Masonry

Roofs

City of Milwaukee Historic Preservation Staff

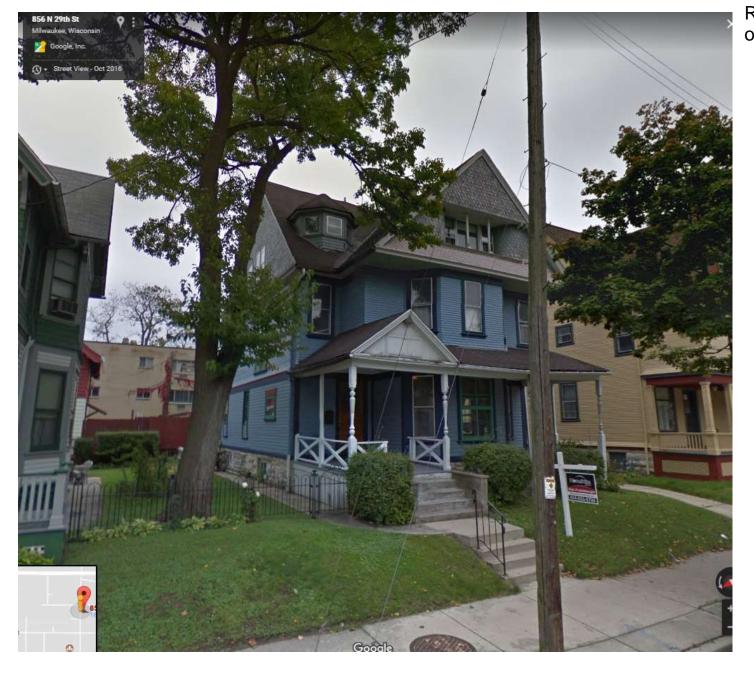
Chimney details showing approiate step flashing. Mortar must be no harder than Type O and preferably made with natural and not Portland cement. A concrete cap may be installed, but no bricks may be removed. Any replacement bricks shall be salvaged cream city brick to match existing.
